# APPENDIX O
## Design Drawings

# PASADENA WATER AND POWER

# MONK HILL TREATMENT SYSTEM

PID-102

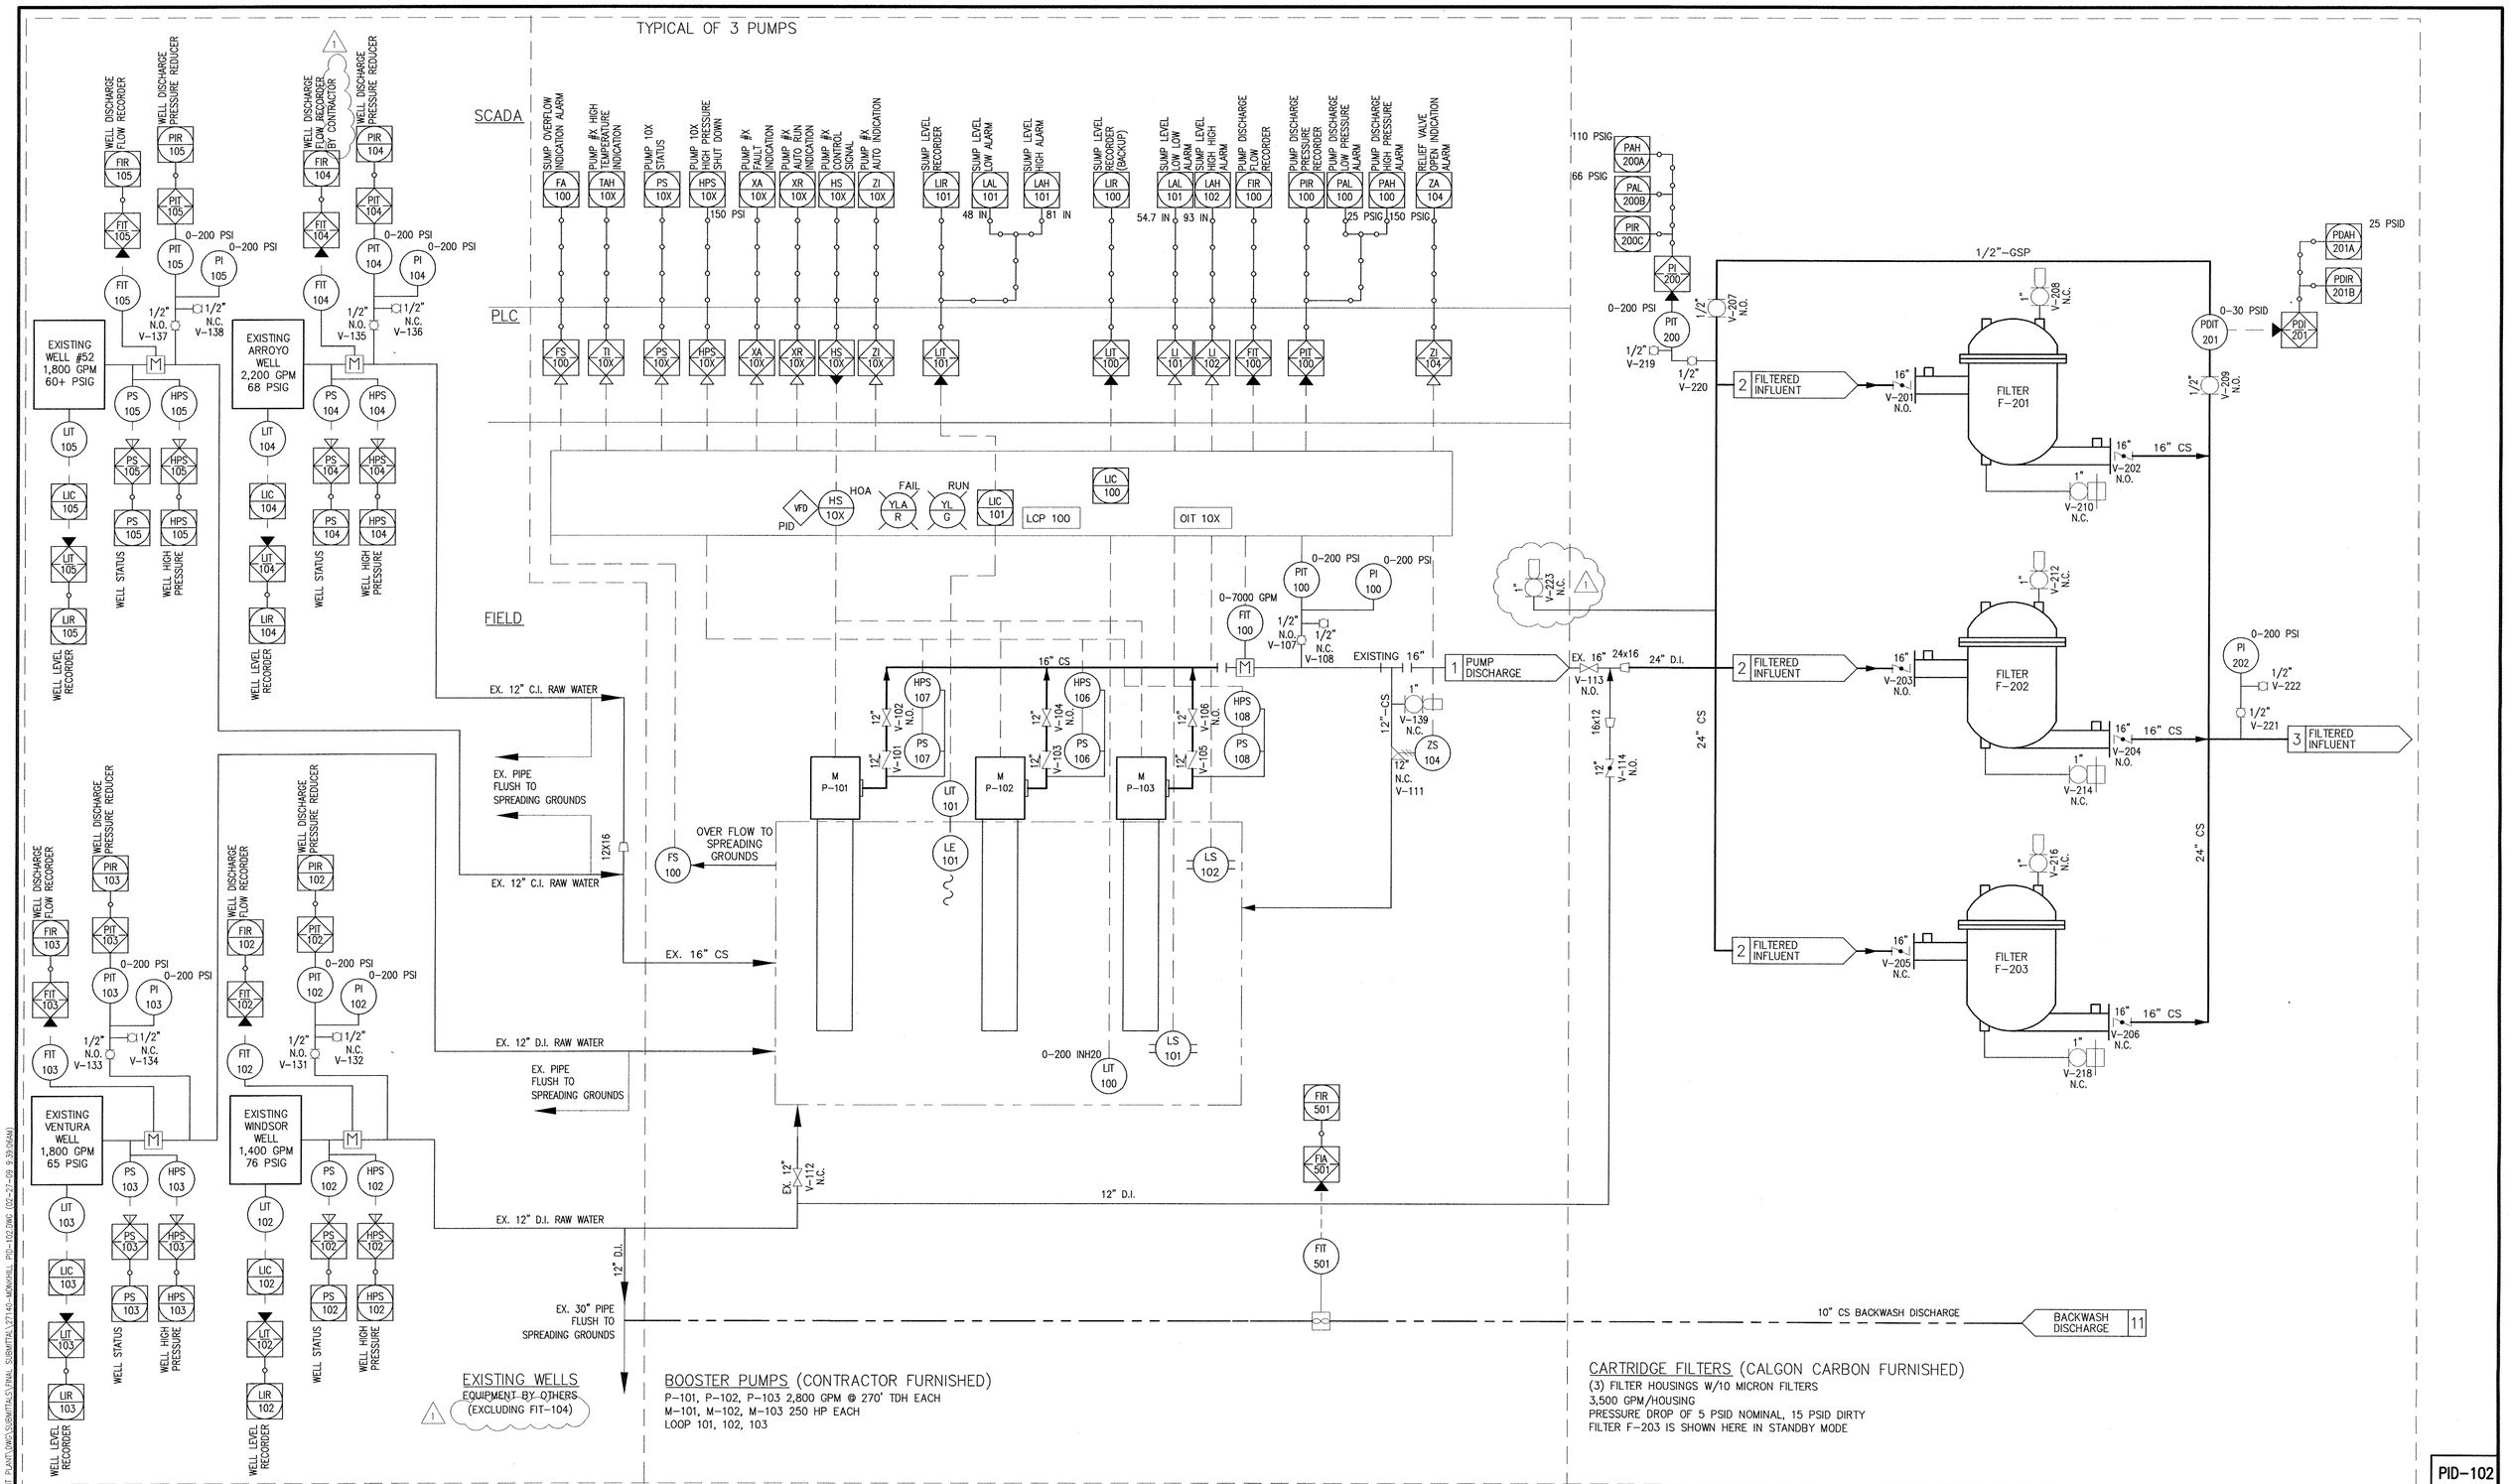
| 46 | **Disinfection Facilities:**<br><br>A. Drawing PID-102 shows the sample point location for the chlorine analyzer before the static mixer. Drawing C-102 shows the sample point before the mixer.<br>B. PID-102 also shows a "monochloramine" sample point after ammonia injection. C-102 shows an "ammonia sample connection" and an ammonia analyzer.<br>C. The ammonia sample line length and diameter of 2 inches may result in long lag times before the analyzer can read the sample. Can the sample time be reduced? | A. PID-102 was inaccurate and has been updated.<br><br>B. The intent of this comment is unclear.<br><br>C. The ammonia sample line is ¼-inch tubing installed inside of a 2-inch sleeve. Sample times should not be an issue while drawing from this size of tubing. |

PID-108

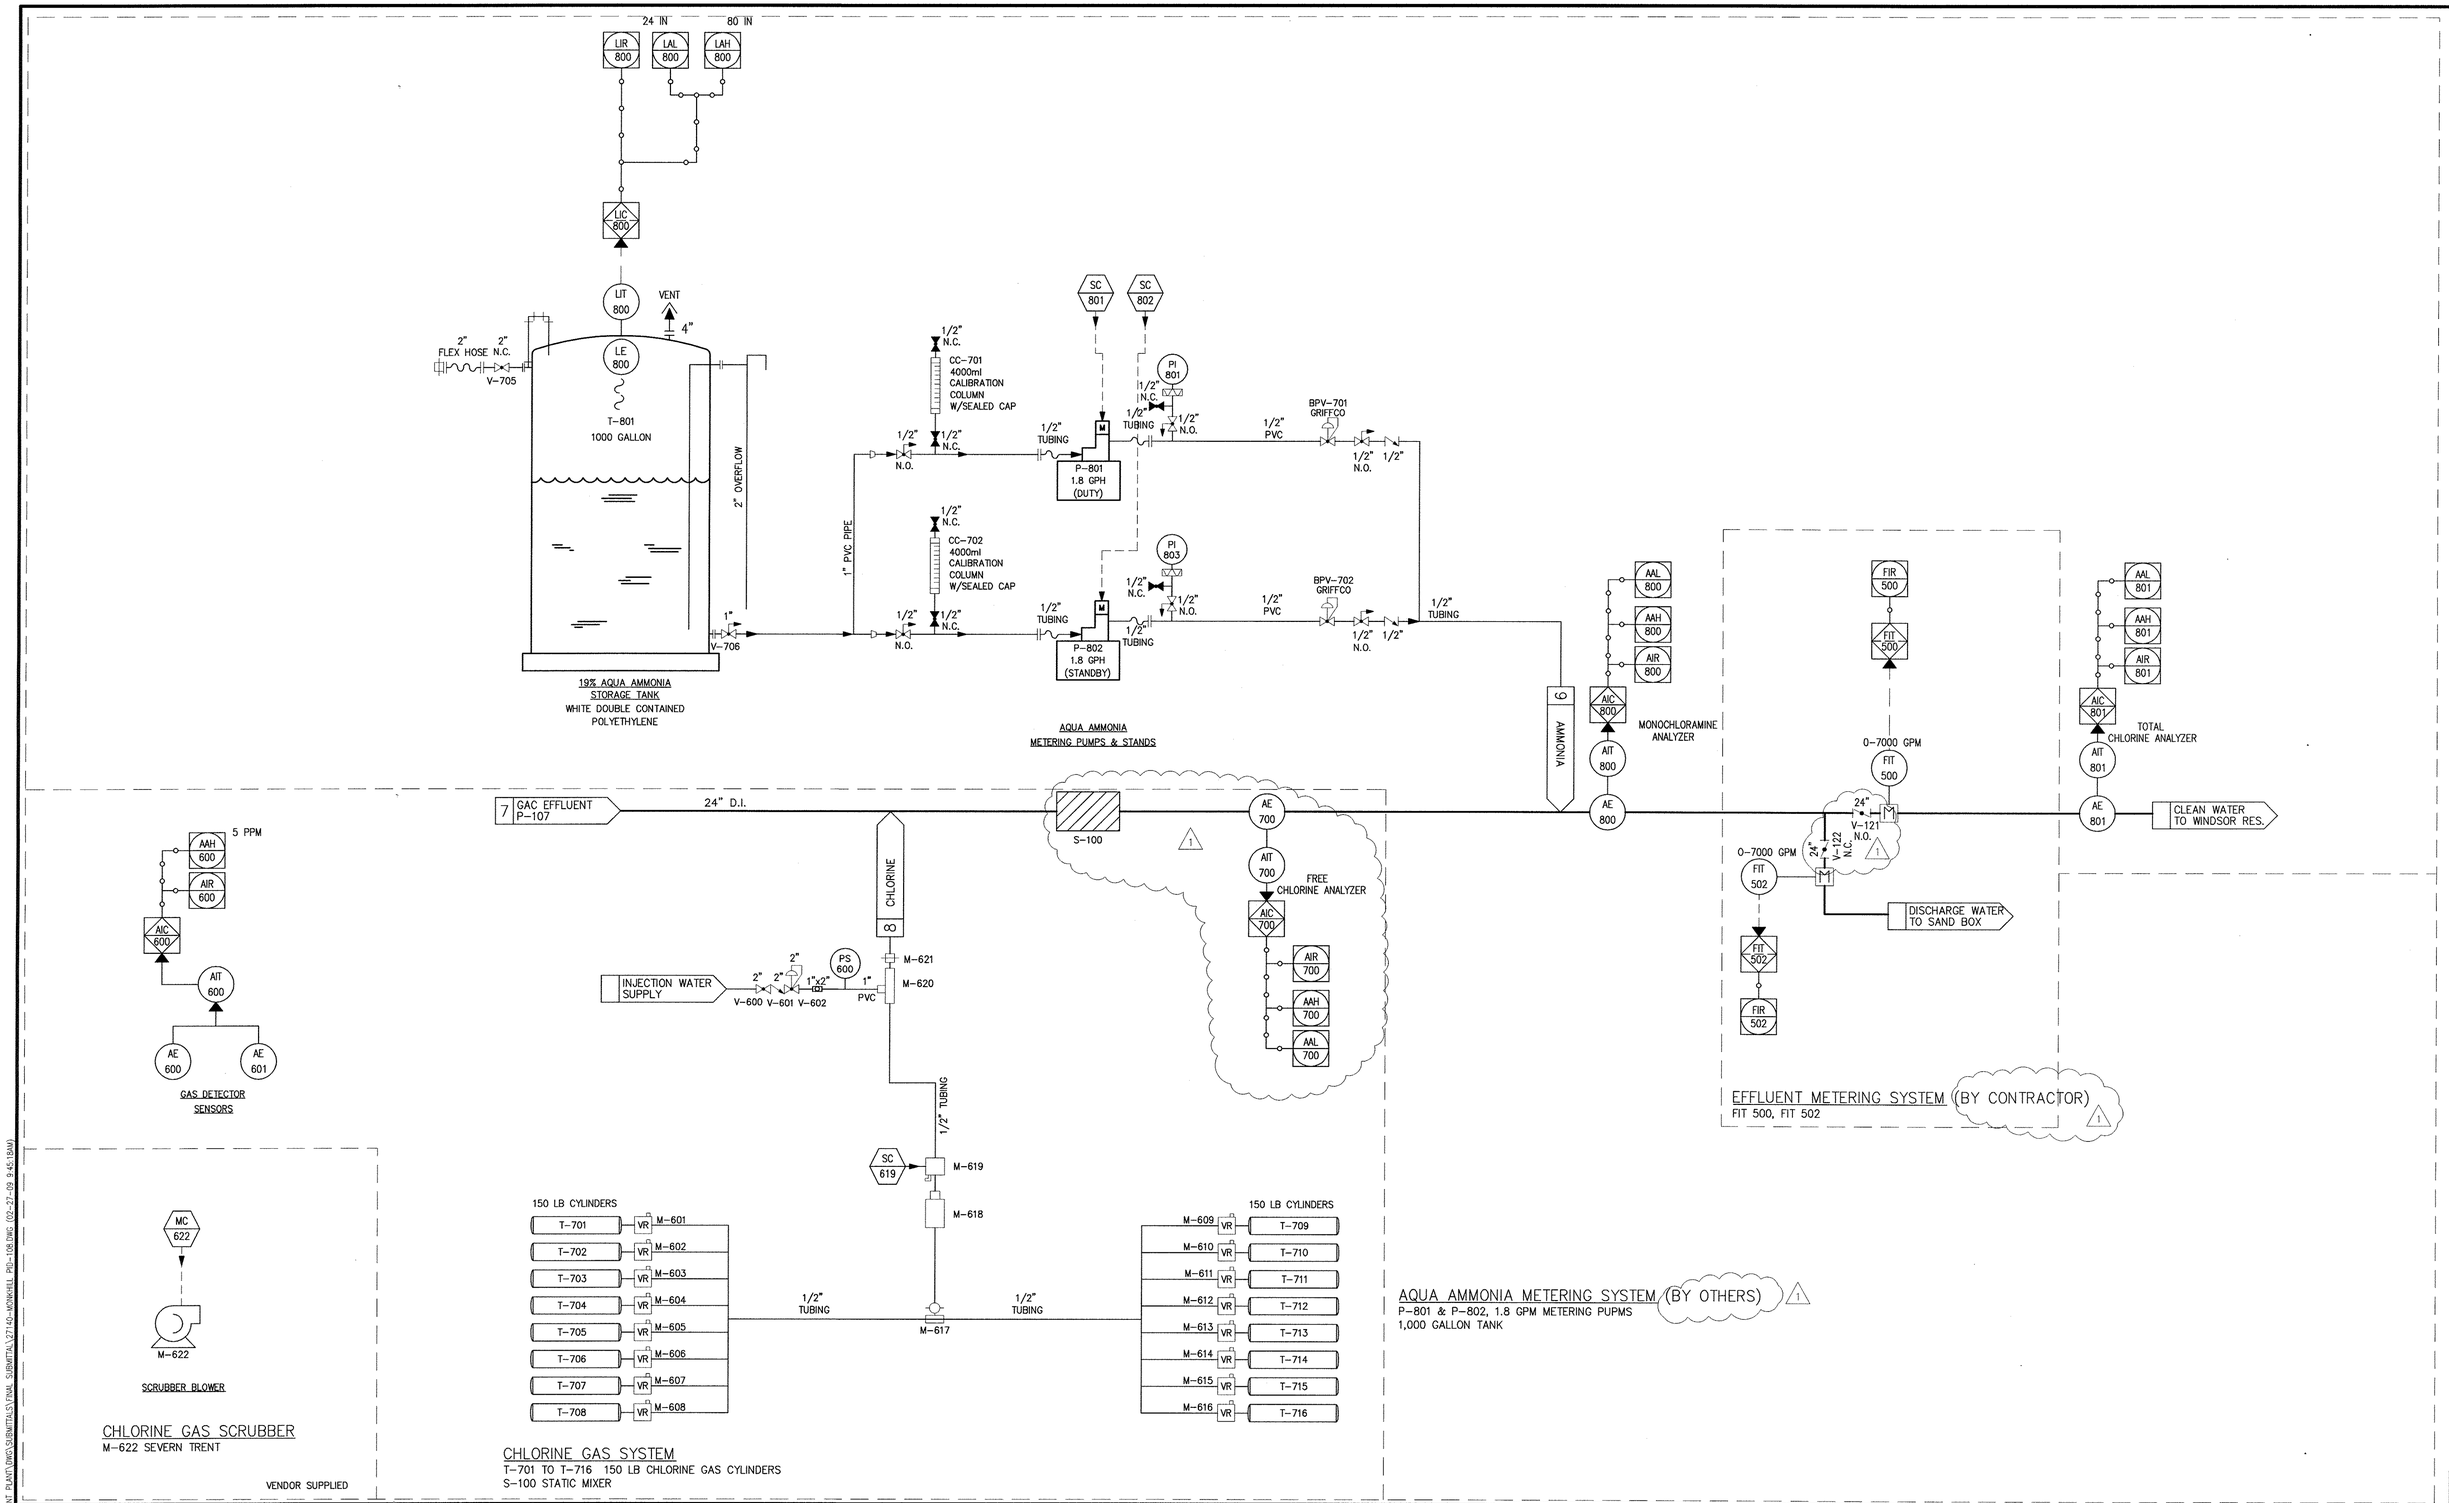
<tr><td>8</td><td>1750</td><td>36</td><td>8, 6. 4</td></tr>
<tr><td>12</td><td>2600</td><td>54</td><td>10, 8, 6</td></tr>
</table>
</td>
</tr>
<tr>
<td>10</td>
<td>2.4.8 and 2.5: Line tag 7 on PID 108 reads GAS Effluent instead of GAC Effluent.</td>
<td>The line tag on Design Drawing PID-108 has been corrected.</td>
</tr>
</table>
